Car Stereo Service Bulletin

Model: CDX-5040

No. 233

Subject: Service Manual Addition: Ref. Number For Wire
Harness

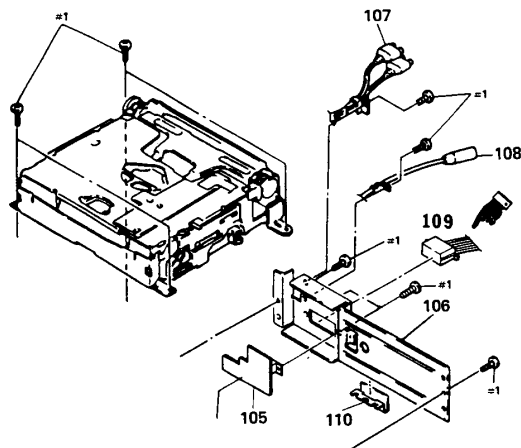
The reference number for the wire harness which includes the accessory, amp remote, and antenna remote lines is missing from the Service Manual.

Solution: Please add the following reference number on page 37 of your Service Manual:

REF NUMBER	DESCRIPTION	PART NUMBER
109	WIRE HARNESS	1-590-764-11
